HOPE CREEK GENERATING STATION  
DOCKET NO. 50-354  
FSAR COMMITMENT STATUS THROUGH AUGUST 1984

ATTACHMENT I  
HOPE CREEK GENERATING STATION  
FSAR COMMITMENT STATUS THROUGH AUGUST 1984

QUESTION 220.21 (SECTION 3.7.2)

FIGURE 210.21-13  
 RESPONSE SPECTRA COMPARISON,  
 UNIT 1 REACTOR BUILDING AT ELEV. 54' -0",  
 VERTICAL, SSE, 2% DAMPING

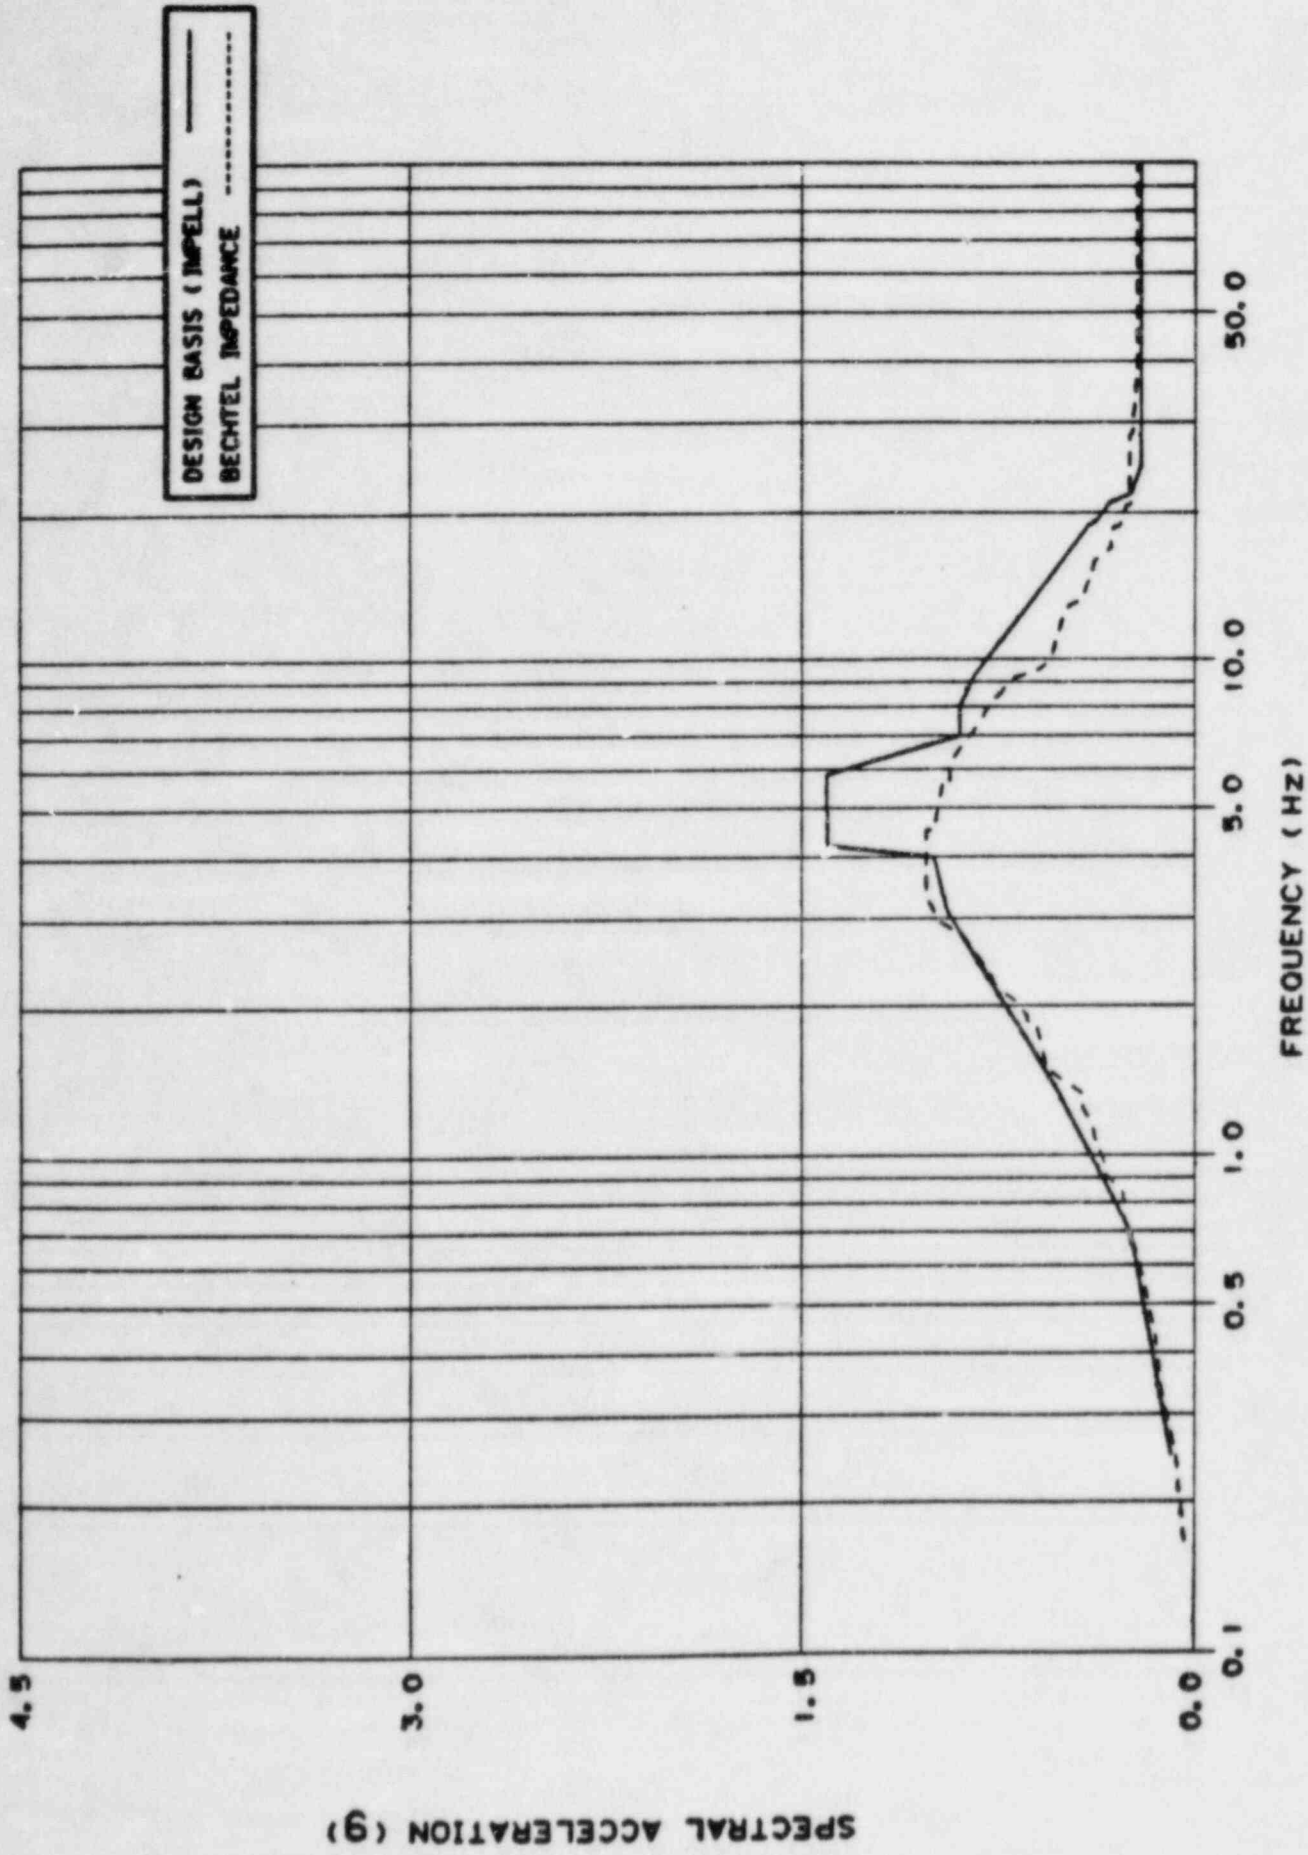
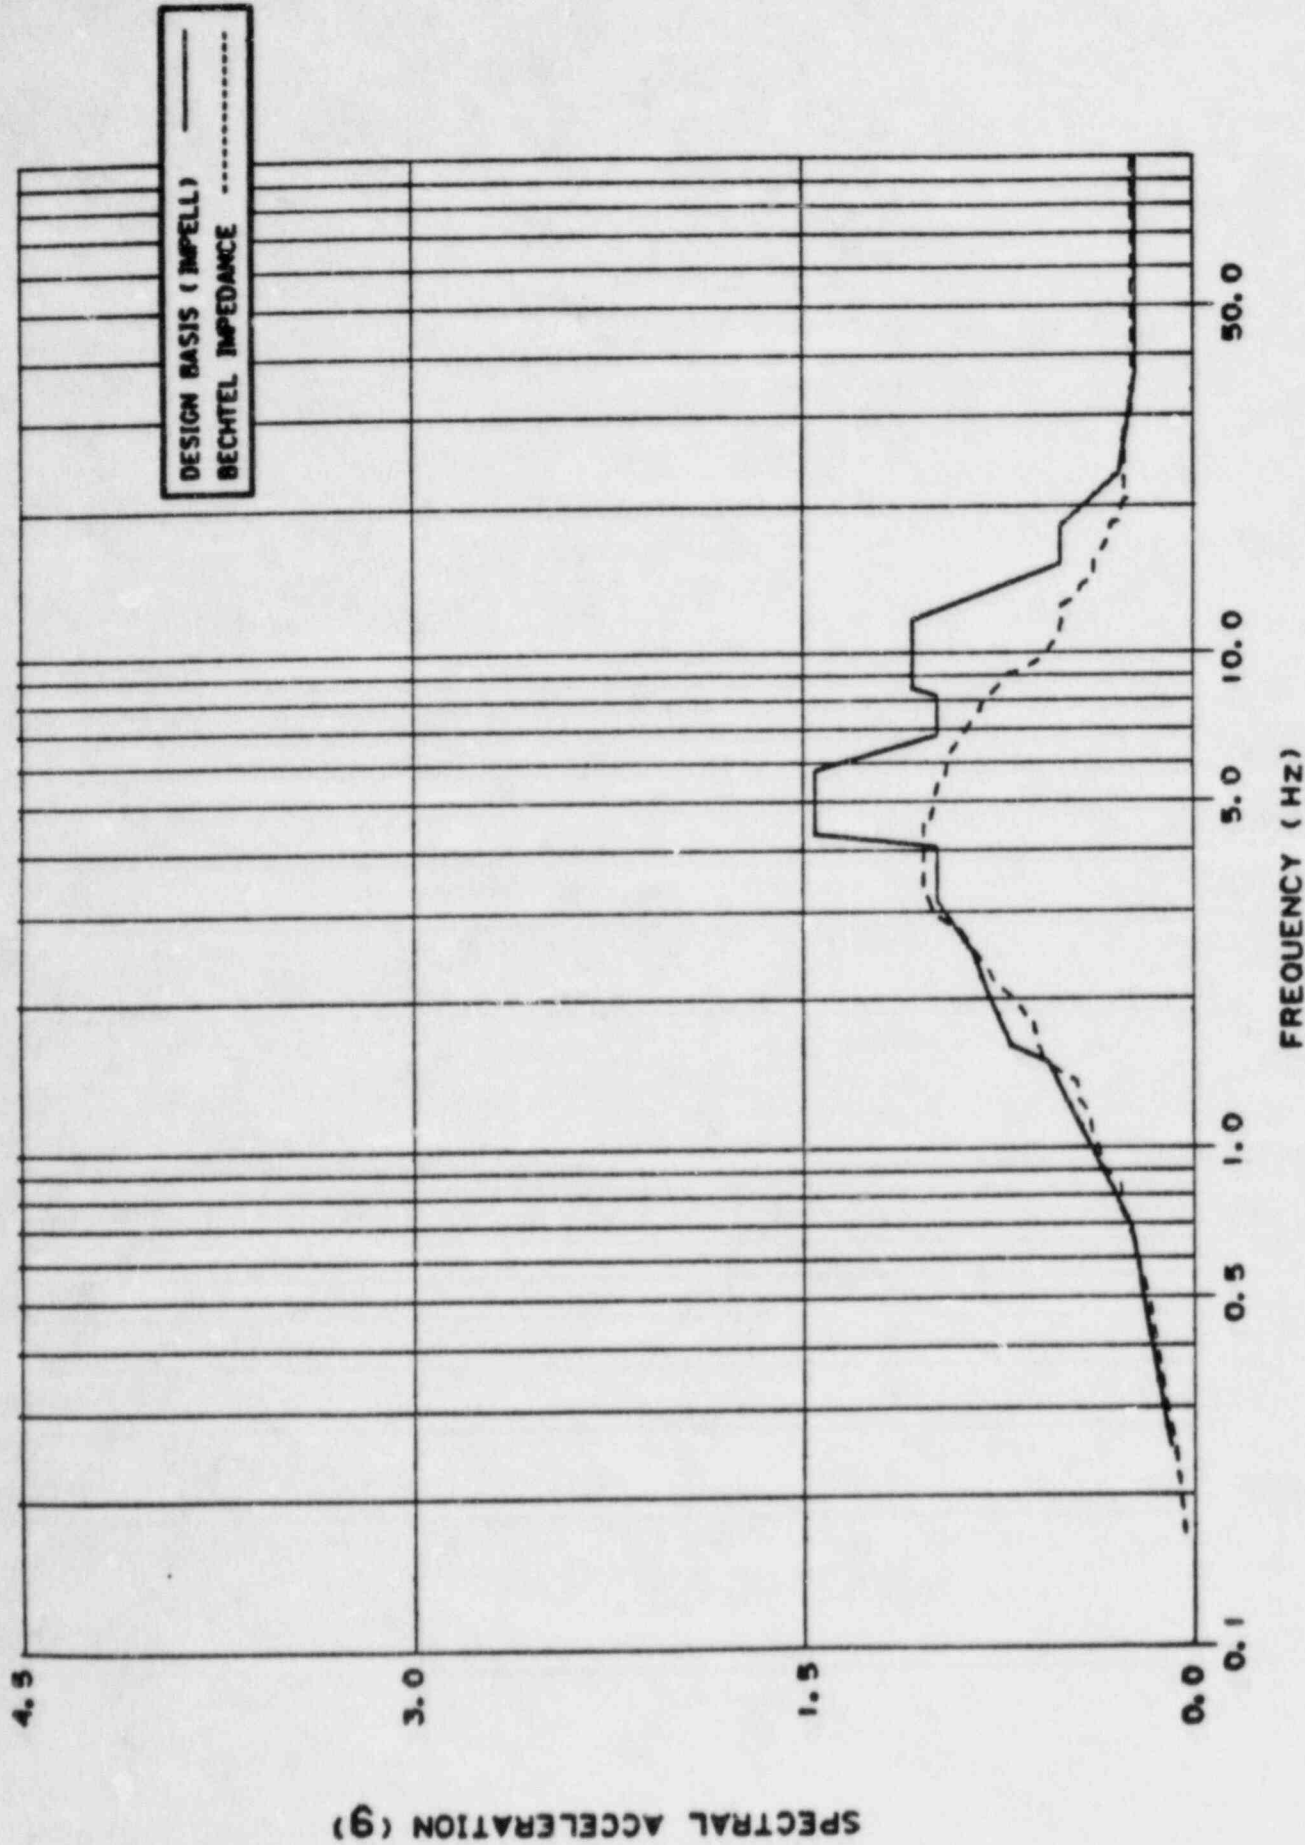
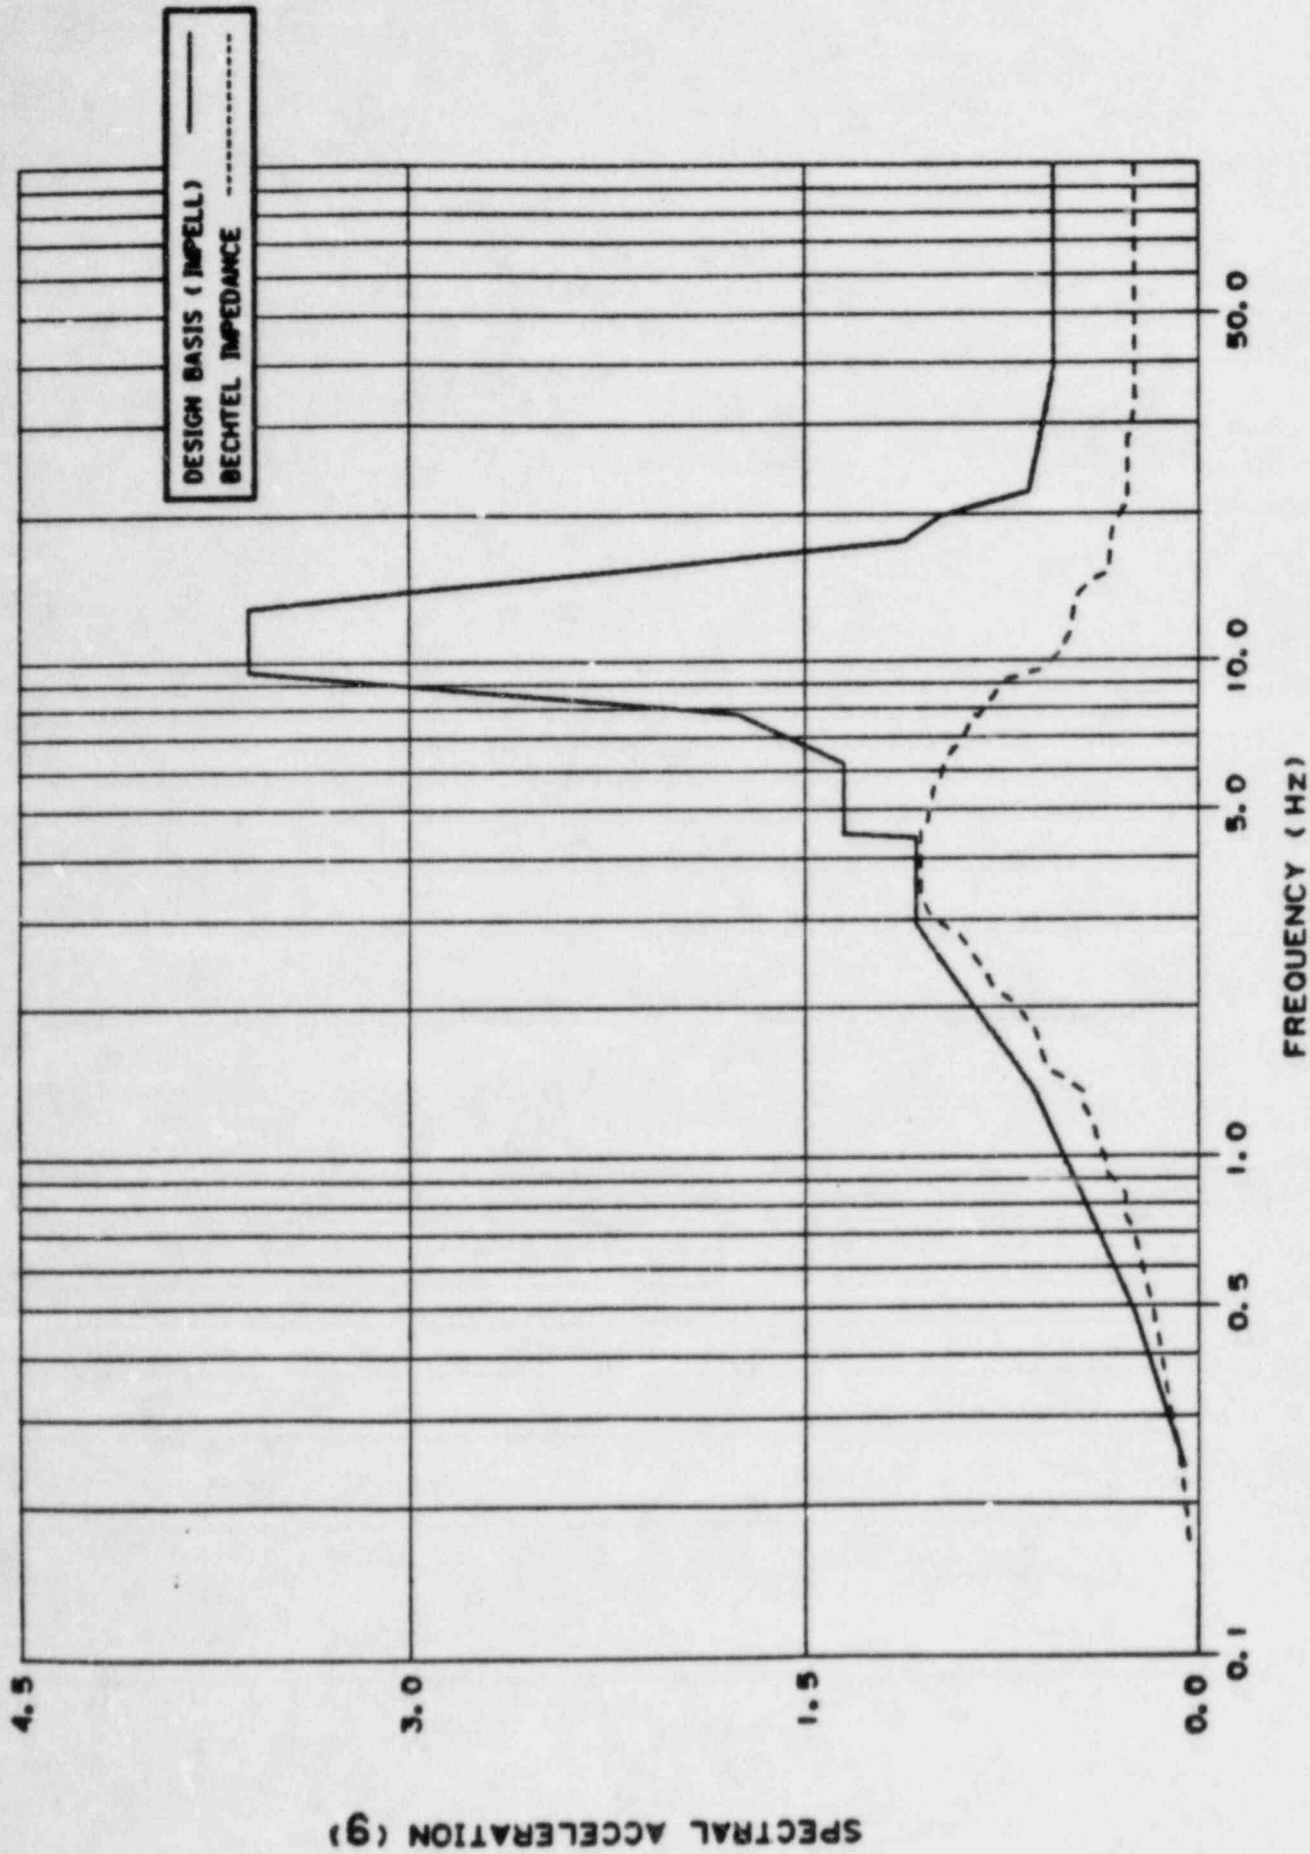
The Hope Creek soil-structure interaction analysis is performed by applying a specified earthquake input motion at the base of the finite-element model. The base level input motion is generated through a deconvolution analysis. The applicable SRP criteria for soil-structure interaction analysis require that both the half-space and finite-element approaches should be considered. (For details refer to SRP 3.7.2-11.4). Public Service should perform necessary analyses to demonstrate conformance to the criteria.

Figures 220.21-1 through 220.21-54 show a comparison of the 2 percent damping response spectra obtained from the design basis finite element and the impedance analyses for the reactor building, auxiliary building and the service water intake structure (SWIS).

¶ For the reactor and auxiliary buildings, the peak spectral accelerations obtained from the impedance analysis are generally lower than those obtained from the design basis analysis. However, the impedance analysis response spectra are not completely enveloped by those obtained from the design basis analysis, especially in the frequency range from 1.0 to 3.5 Hz. Also, there are some local exceedances in the higher frequency range, as shown in Figures 220.21-1 through 220.21-36. ¶ For the SWIS (Figures 220.21-37 through 220.21-54), the impedance analysis response spectra are generally enveloped by those obtained from the design basis analysis at elevation 114.0 feet. For other elevations, the impedance analysis spectral accelerations exceed the design basis spectral accelerations in some frequency ranges. These ranges vary approximately between 1.5 and 10.0 Hz.

forces and moments obtained from the impedance analysis exceeded the design basis values at various locations within these buildings. The auxiliary building seismic shear forces and moments obtained from the impedance analysis are less than the design basis shears and moments.

Since the impedance analysis results are not completely enveloped by the design basis finite element analysis results, sampling studies are conducted to confirm the adequacy of the plant design. These sampling studies include an evaluation of the following items:

In all cases, the items reviewed during these sampling studies can accommodate the loads resulting from the impedance analysis. Therefore, the impedance analysis results have no impact on the plant design.
